# APPEAL OF DECISION

Hill & Locust Partners Original File Number: 4-D-24-DT / 8-A-24-OB

**Re:** Appeal of 8-A-24-OB  
Proposed New Parking Garage and Residential Structure  
Fronting Hill Avenue, Locust Street, and Front Avenue

**TO:** Knoxville-Knox County Planning Commission  
**FROM:** Lindsay Crockett, AICP, Principal Planner/Design Review Program Manager  
**DATE:** July 31, 2024  
**SUBJECT:** Consideration of an appeal of the Design Review Board approval of 4-D-24-DT  
**FILE #:** 8-A-24-0B; Agenda Item #5

# *How is the Henley Street Bridge really impacted?*

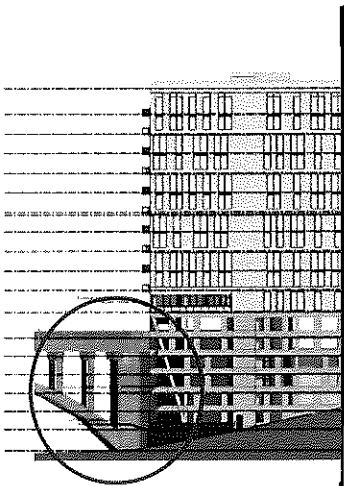
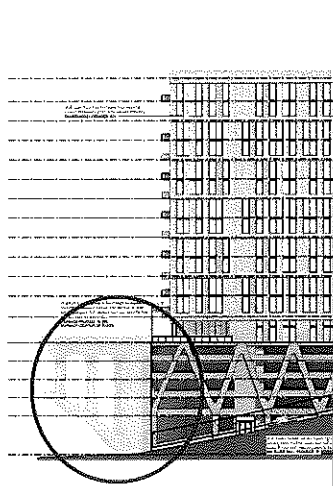
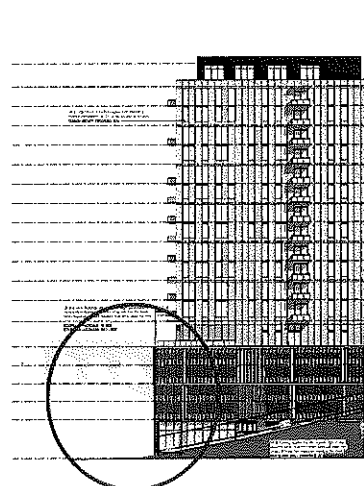
Elevations and renderings were provided from applicant to the Design Review Board and Knox News Sentinel.

# *How is the Henley Street Bridge really impacted?*

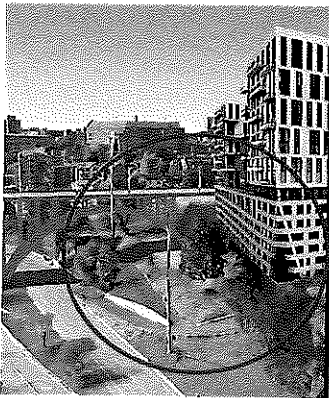
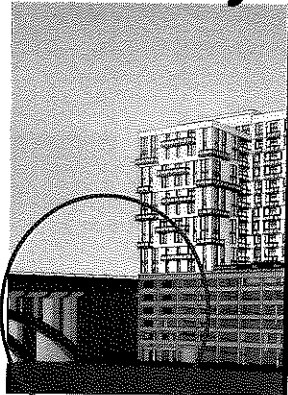
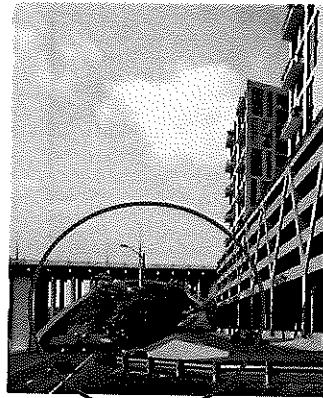
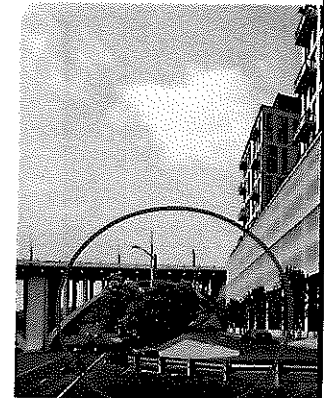
Elevations and renderings were provided from applicant to the Design Review Board, developer meetings and Knox News Sentinel.

### RENDERING

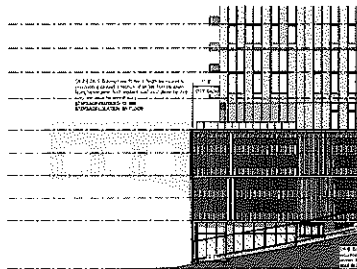
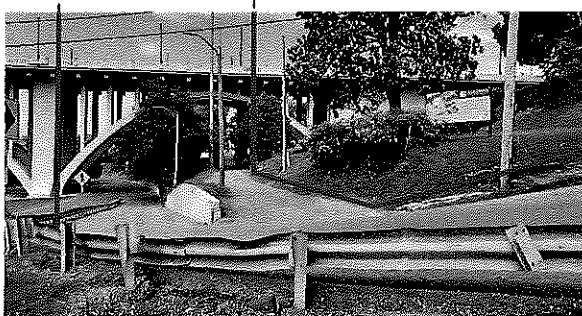
Are the renderings accurate?

This image has been significantly modified to appear to not block the bridge.

The Historic Henley Street Bridge will be obstructed by this building

The applicant provided a composite photo realistic rendering that misrepresents the location of the building to confuse the Design Review Board.

## FALSE RENDERING

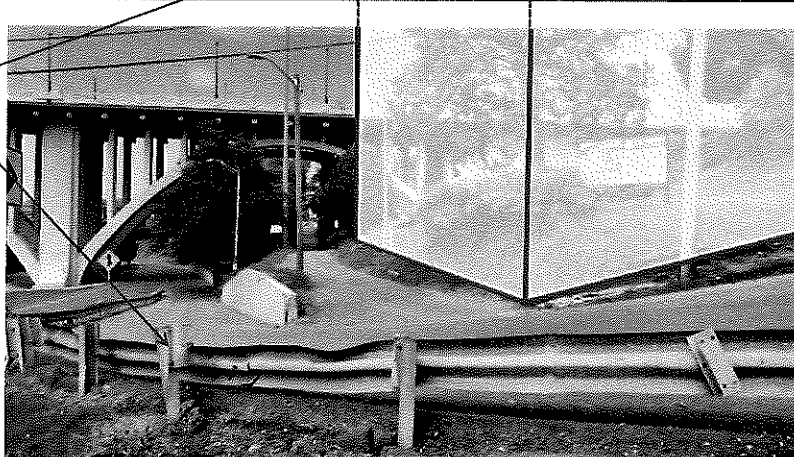
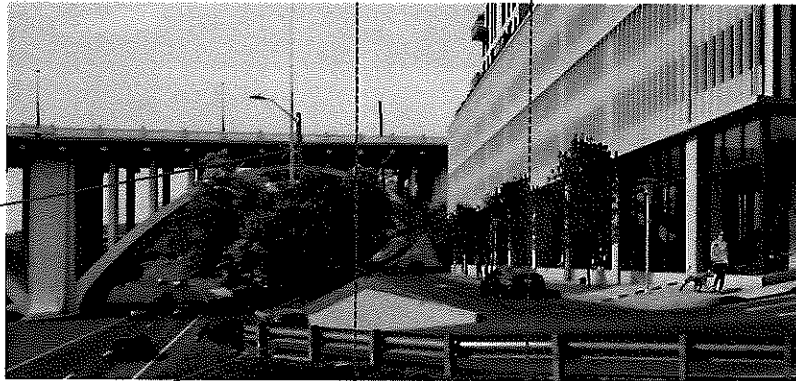
Note the condition of the guardrail and the retaining wall. The above image is not a real photo – it is a false rendering showing false existing site conditions.

Neyland Drive, Front Avenue and all existing site elements in the applicant provided rendering have been manipulated relative to the bridge to intentionally give the false impression that the building will not block views of the Henley Street Bridge.

This image has been significantly modified to appear to not block the bridge.

The Historic Henley Street Bridge will be obstructed by this proposal.

#### **3. GARAGE SCREENING**

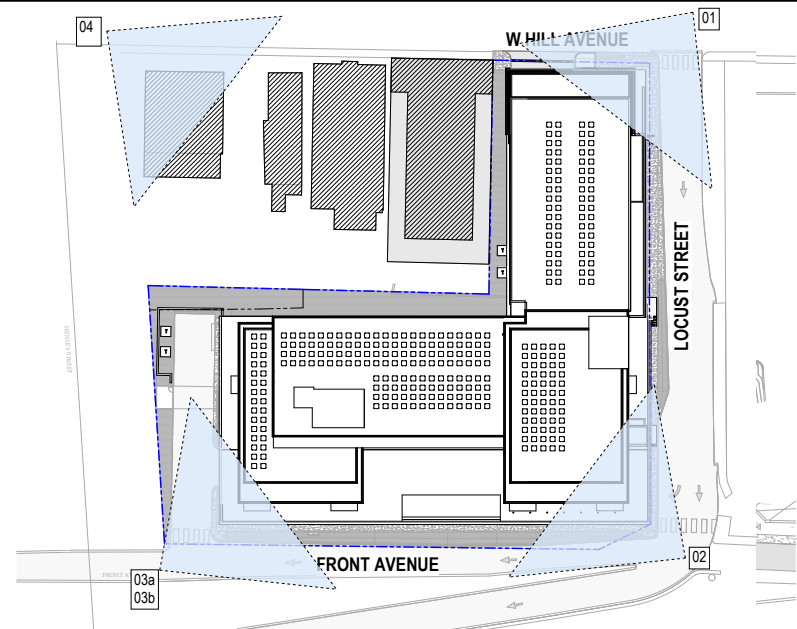
In addition to the 10' building setback along the Henley Street Bridge (incorporated just before the May DRB meeting), the building massing has been further reduced along the western portion of the building adjacent the Henley Street Bridge, creating distinct building modules within the overall building composition. The white portion of the Western wing of the building fronting Henley has been reduced by two stories, with a partial penthouse floor added to that wing of the building. The change in material and the setback at the upper penthouse floor results in a visual reduction of two floors of the white massing. The overall building composition now terraces from Locust Street down to Henley Street, resulting in a more pedestrian-scaled building for those walking across the bridge.

In order to accommodate the reduction in building massing and subsequent reduction in residential program along Henley Street, an additional partial penthouse floor has been added to both the Hill Ave module and the Locust Street module of the building. The change in material at the upper penthouse floors on all three modules provides some massing relief at each of the upper stories of the modules, while also providing a clearly delineated tripartite composition (base/middle/top) per the Downtown Design Guidelines. The modified roofline, enhanced by the added building steps and penthouse setbacks, reinforces the appropriateness of the building's scale in two ways: 1. From a pedestrian perspective, the upper penthouse setbacks recede from the building façade giving the appearance of one less floor; 2. From a distance, the upper penthouse story provides more articulation in the roofline, providing massing relief while making the building feel less monolithic.

The parking garage has been screened with vertical metal fins, angled to visually obstruct the garage structure while maintaining the required amount of openness to achieve natural ventilation of the parking garage. The metal fins are two stories in height, giving the appearance of two stories of parking rather than four, while maintaining a scale complementary to the Henley Street Bridge. The composition of concrete columns at street-level with vertical fins above is subtly referential to the massive concrete bridge piers touching down along the river with the repetitive rhythm of its pedestrian level guardrail above. The result is a thoughtful, timeless design approach to the garage treatment that complements the architectural language of the building above.
